## ADDENDUM NO. 2

**PROJECT NAME:** Wick Alumni Center Life Safety & HVAC Improvements  
**UNL PROJECT NUMBER:** C120P021  
**BID INVITATION NUMBER:** 2222-13-7200

**CONSULTANT:** Farris Engineering  
**ADDRESS:** 818 P Street, Suite 100

**DATE OF ISSUANCE:** September 11, 2013  
**DATE OF BID OPENING:** September 18, 2013

**SHEET NO**  
**M2-2**

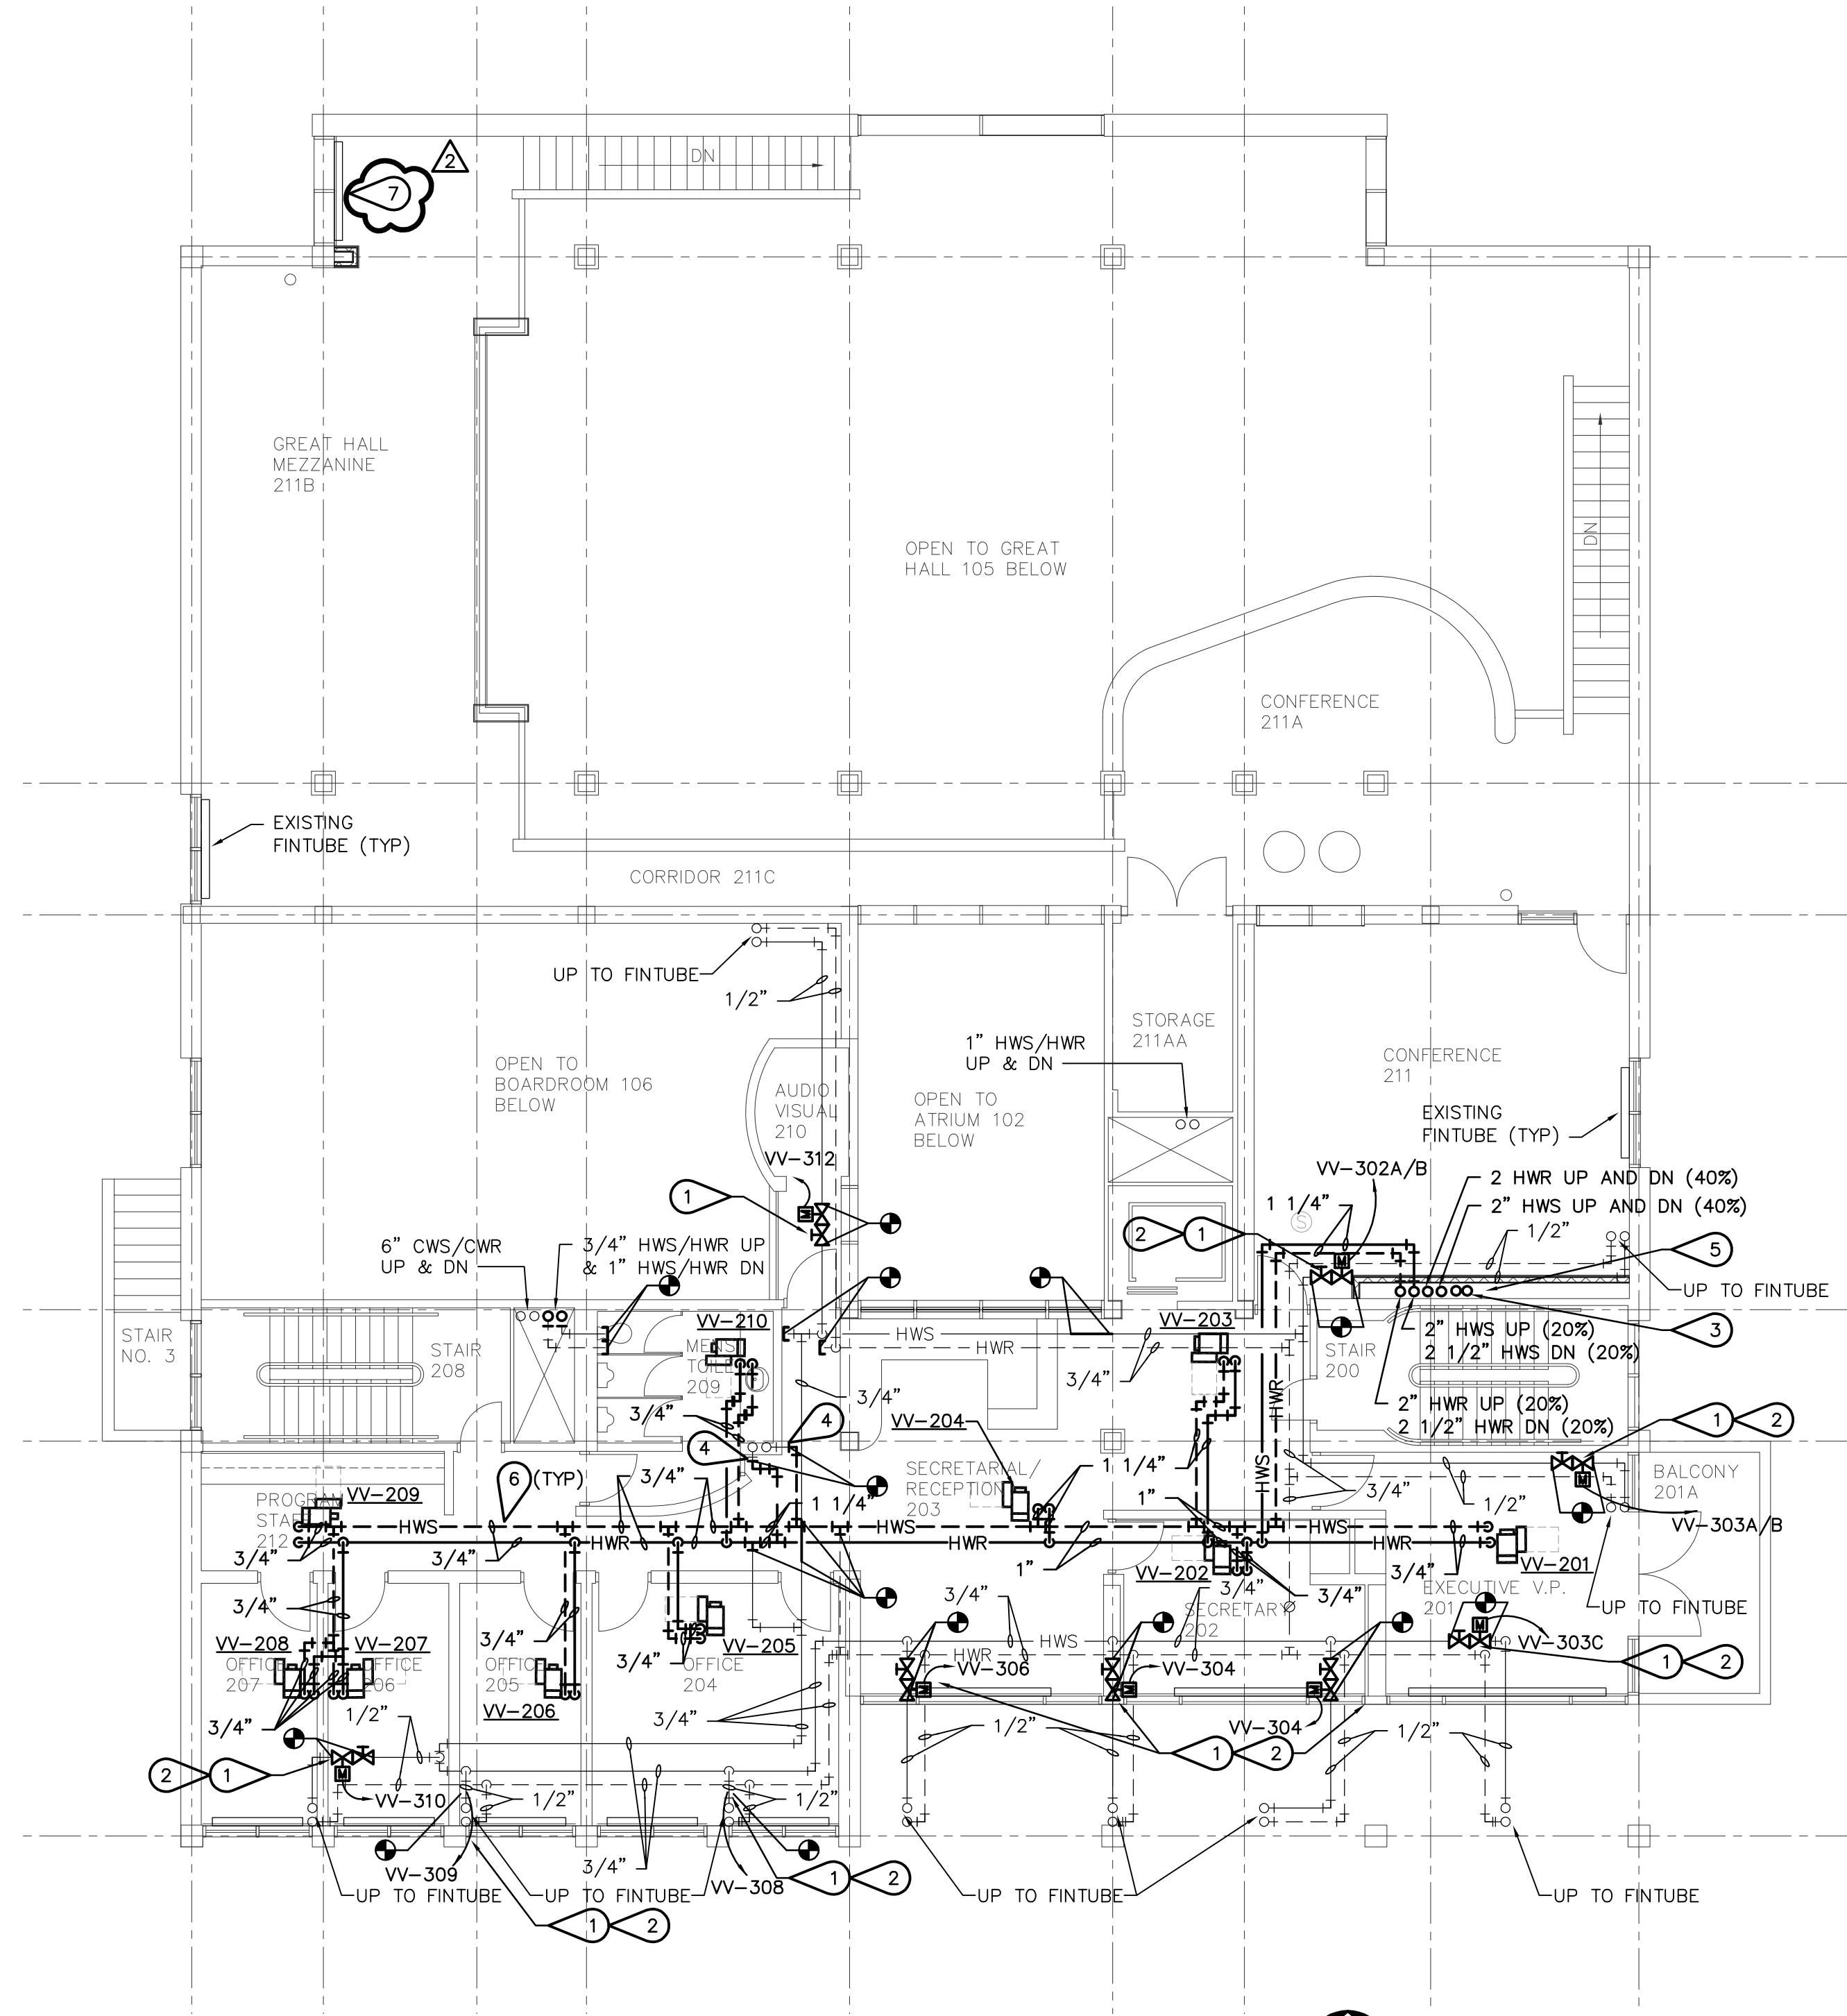
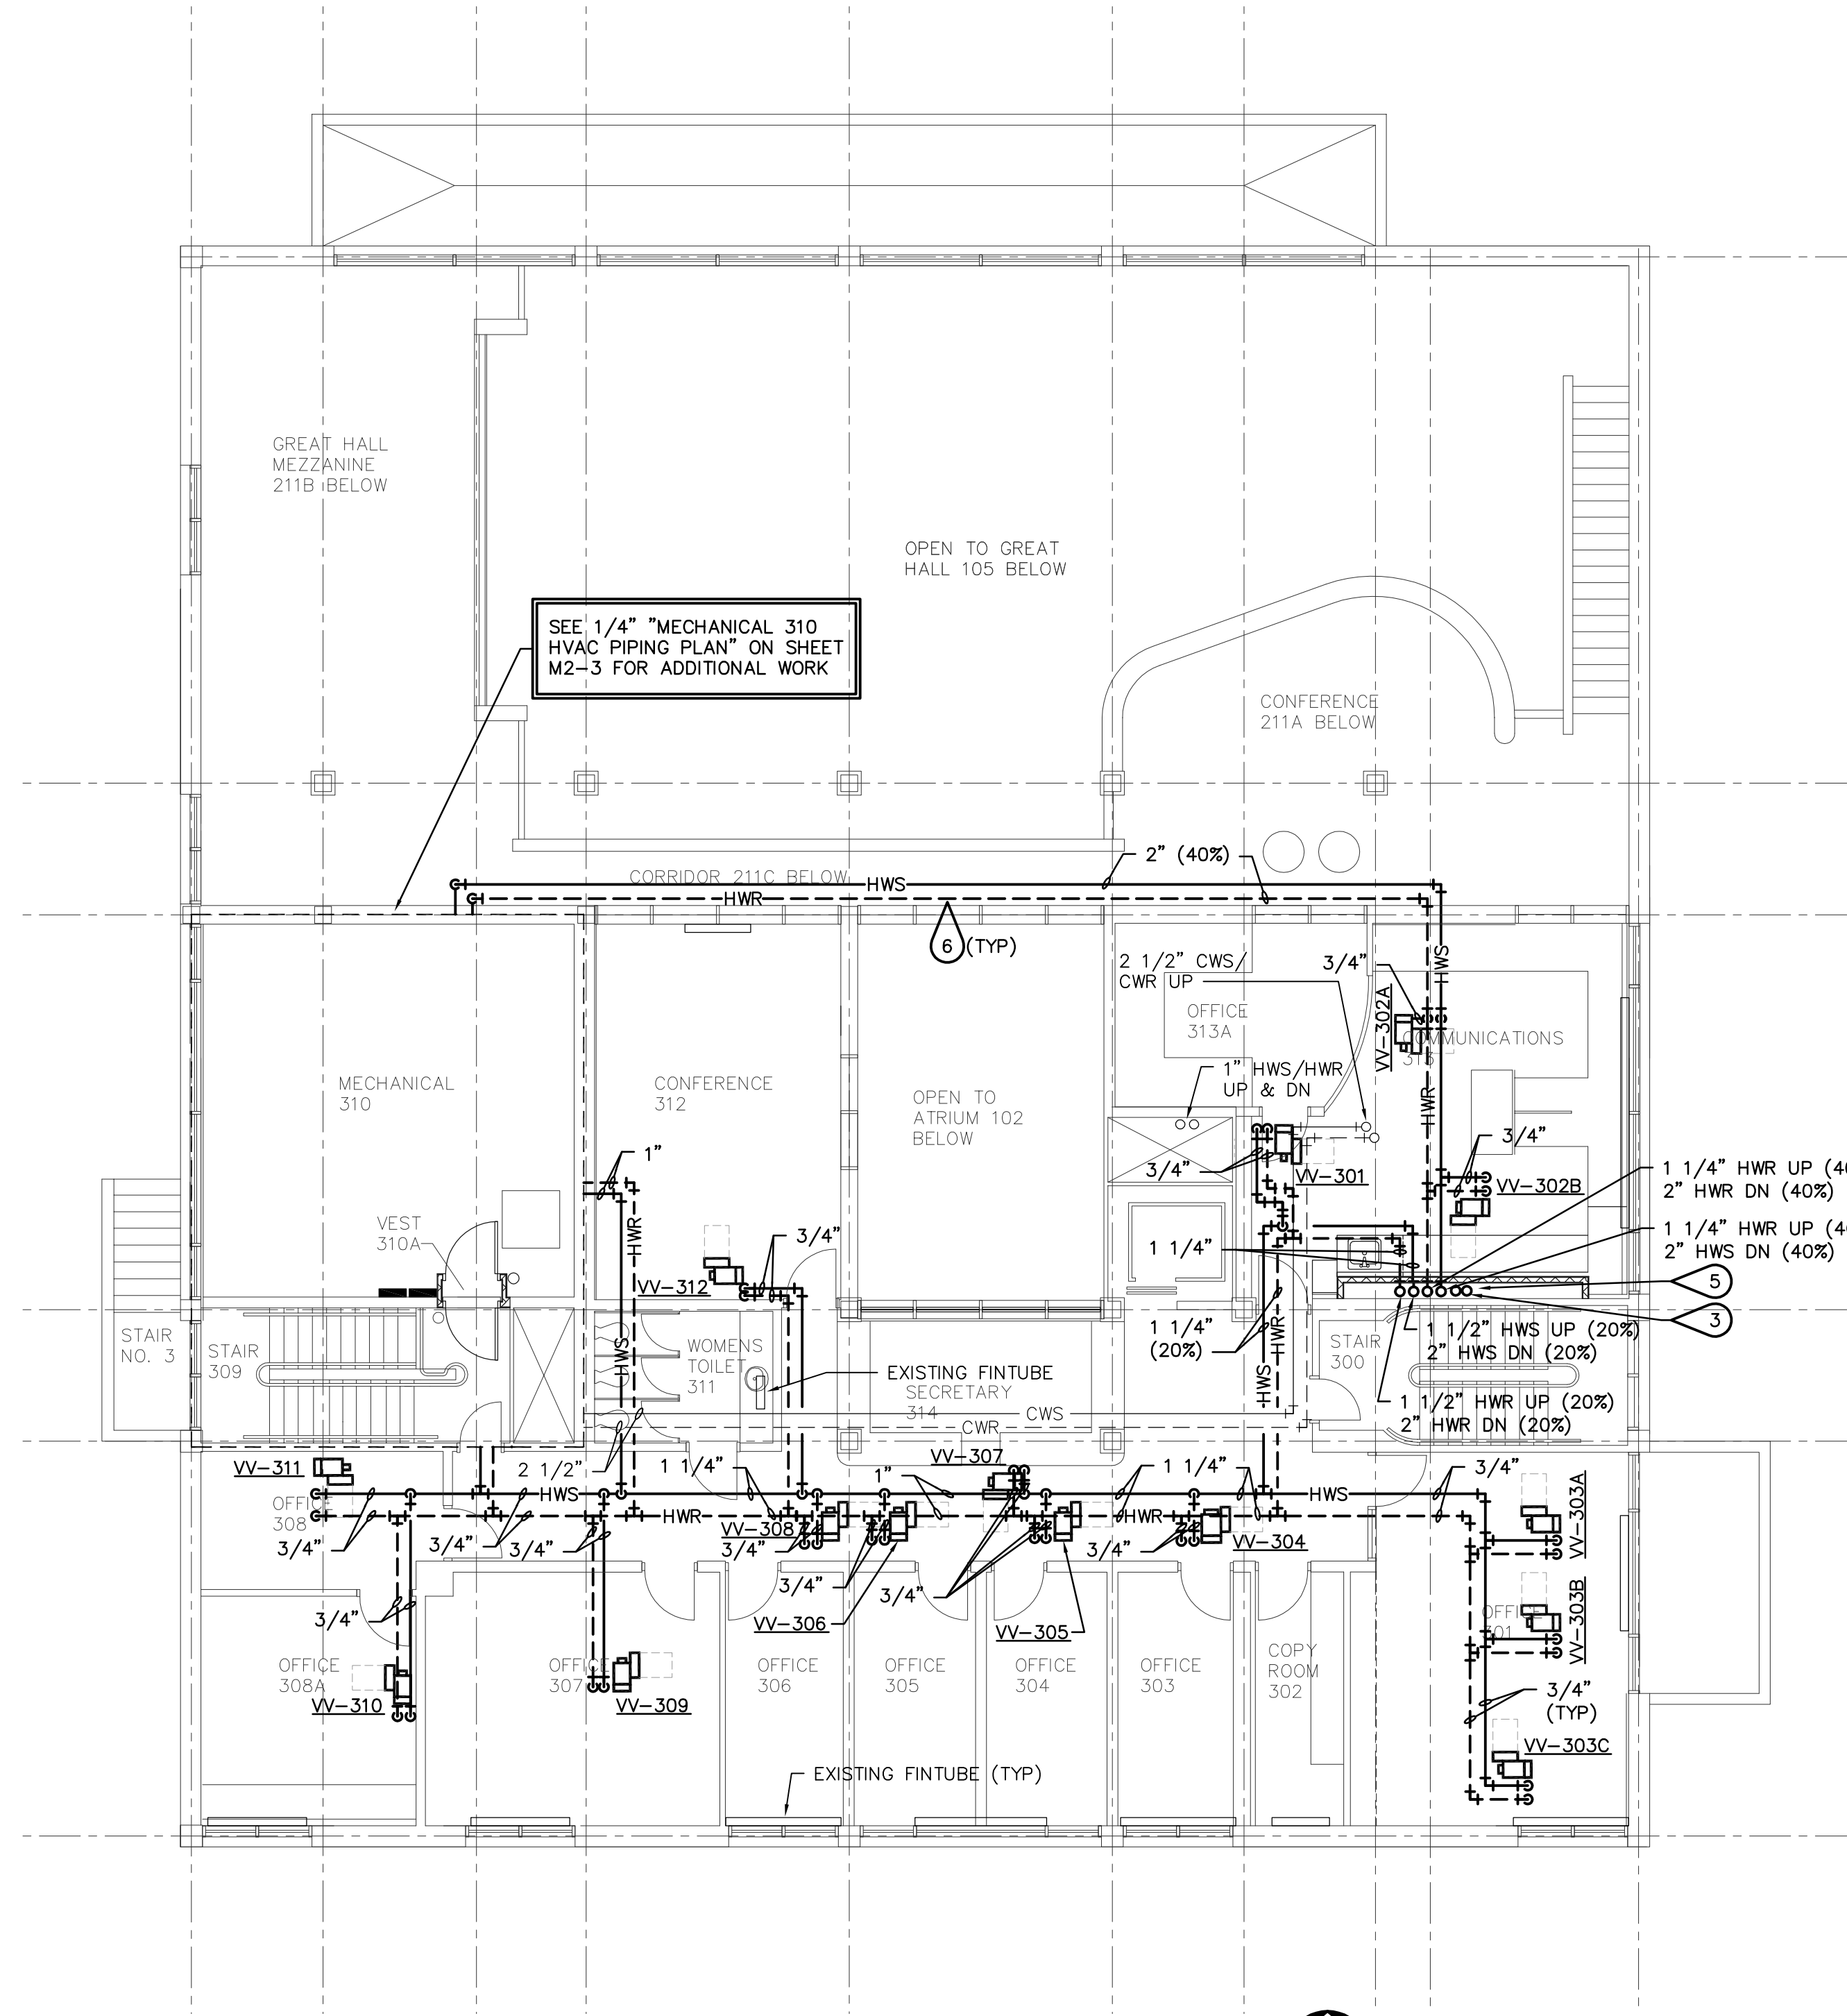
1. This sheet has been reissued in its entirety as a part of Addendum No.2.
2. Mechanical Keynote #7 has been added.

- 6 REFER TO PIPE INSULATION DETAIL 4/M5-2 (TYP).
  - 7 REMOVE AND REINSTALL THE RADIATOR UNDER THE WINDOW AT THE NORTH END OF THE GREAT HALL MEZZANINE 211B-COORDINATE TIMING WITH ARCHITECTURAL WOODWORK TRADE.

**TYPICAL VARIABLE FREQUENCY DRIVE INSTALLATION 10**  
NO SCALE

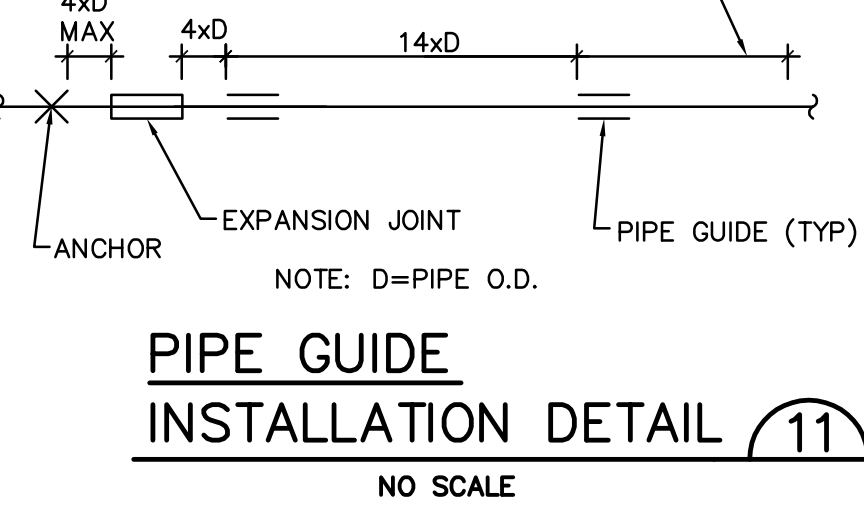
1. This sheet has been reissued in its entirety as a part of Addendum No.2.
2. Removed detail "FLUSHING PIPING CONNECTION" and added new detail "TYPICAL VARIABLE FREQUENCY DRIVE INSTALLATION".

**NOTES:**  
1. VFDs AND SEPARATE FUSED DISCONNECTS SHALL BE PROVIDED BY UNL BSM AND INSTALLED BY ELECTRICAL CONTRACTOR. ADDITIONAL LOCAL SERVICE DISCONNECTS, WHEN REQUIRED, ARE TO BE PROVIDED BY ELECTRICAL CONTRACTOR.  
2. EACH MOTOR MUST BE WIRED IN SEPARATE ELECTRICAL RACEWAYS. (ONE CONDUIT PER MOTOR)  
3. VFDs MUST BE INSTALLED PER MANUFACTURER'S INSTRUCTION PROVIDING APPROPRIATE FREE-AIR SPACE BETWEEN DRIVES.  
4. ALL VFD MANUALS AND ADDITIONAL PARTS/CONNECTORS ARE TO BE TURNED OVER TO UNL BSM.
